IN THE MATTER OF:
DAVIS BESSE INCIDENT

DOCKET NO: --- 50-346

Discuss PORV Controls and Instrumentation.

MEETING BETWEEN THE NRC FACT-FINDING TEAM AND TOLEDO EDISON

FIG. 1
ASSEMBLY OF PRESSURMATIC
VALVE STYLE HPV-SN

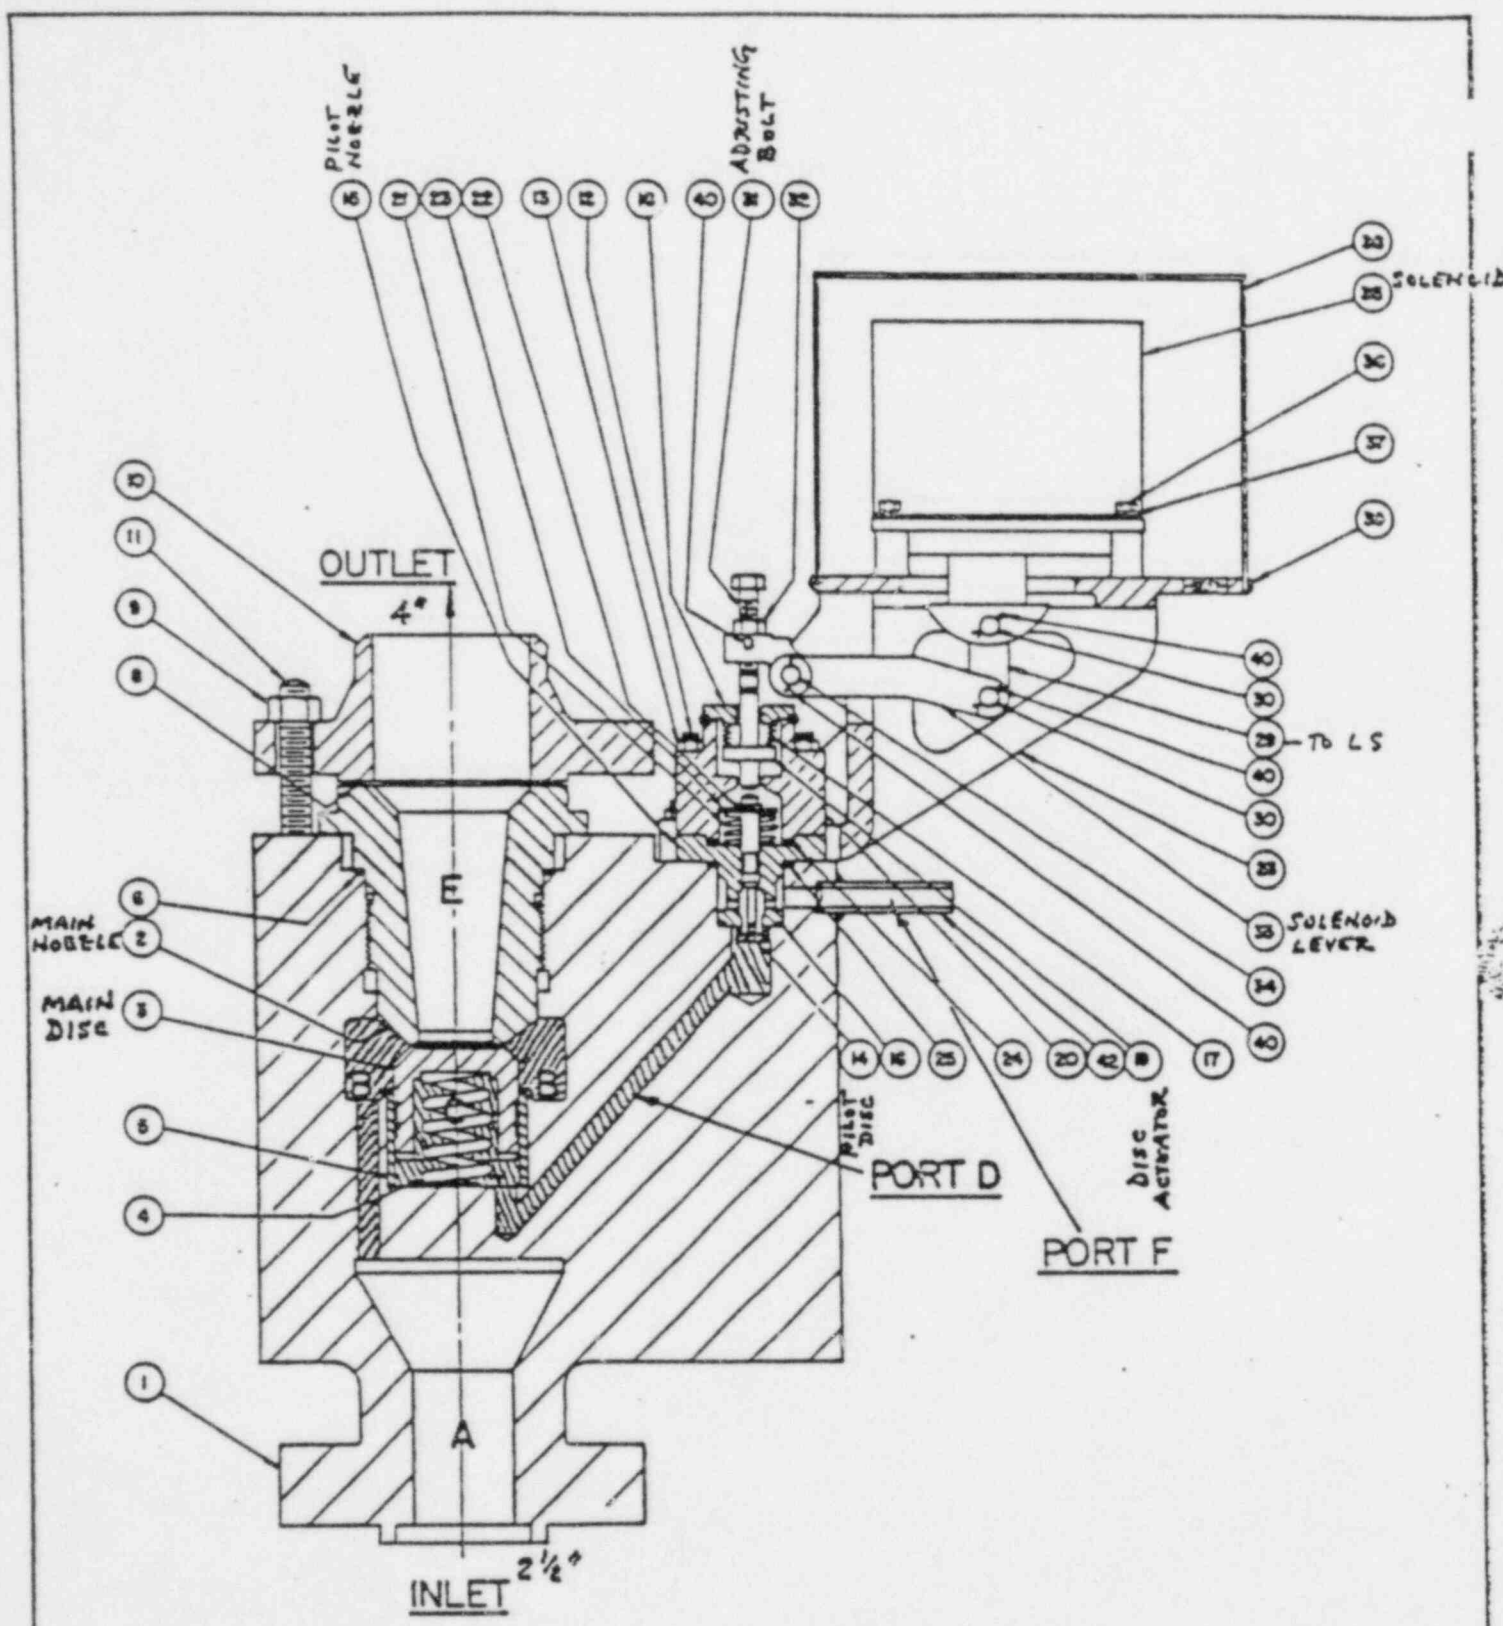
MR. BEARD: Let me put this figure along with the record, and I will give you a copy of it also. It is the same one that is out of the tech manual that you provided us, with one difference, and that is for some of the balloons around the outside, for example, Item No. 3, I have annotated that like at main disc. I put some numbers on it and a couple of things like that, and I have cross-hatched a couple of the cavities that were mentioned in the discussion so that they are more readily apparent. That is all.

1 MR. BEARD: Now one of the questions that I had
2 was in the description in the tech manual of the normal
3 condition of this with the plant at full power and at the
4 right pressure. So this thing would be closed.

6 MR. BEARD: They talk about cavities B, C and D
7 being all at the same pressure.

9 MR. BEARD: And then they say that because the
10 pressure at the outlet Port E at the top is low, therefore
11 the valve disc is seated.

16 What I was trying to get at, Tom, is in the tech
17 manual, as I remember it, it talks about since the pressure
18 at B and C cavities is high, and that is system pressure ---

23 MR. BEARD: Now it seemed to me that a better
24 description was that the pressure above and below the valve's
25 main disc, in other words, the pressure in cavity B is

1 also somewhat above the disc ---

3 MR. BEARD: --- and cavity C is on the underside,
4 those two pressures really balance the main disc and the
5 spring is what keeps it closed.

12 MR. BELL: So it is a differential area that is
13 holding the main disc closed?

18 MR. BEARD: Okay. So it is the difference not
19 in pressures and really not in E. See, the point I was
20 trying to get at is the pressure in E is not really the
21 driving force for the valve disc as much as it is the
22 pressure on the underside and overside of the main disc as
23 I thought.

1 to say. I thought the pressure on the outlet port is really
2 sort of immaterial.

5 When the solenoid is energized, I take it the
6 plunger is sucked upward on the diagram and that causes the
7 bolt, the adjusting bolt they call it, to move downward?

6 MR. ISLEY: Not according to Crosby. Their
7 description of the purpose for Spring C is essentially a
8 shipping holder and just an assist to get the valve closed,
9 and the valve should operate fine with Spring C, or with the
10 spring underneath the disc not even there. If the spring
11 were removed, the valve should work fine.

14 MR. ISLEY: Yes. I think if you were to look at
15 the surface area available in there and compare the two
16 surface areas, you would see that there is more surface area
17 underneath the disc to compensate for that.

8 MR. ISLEY: That is correct.
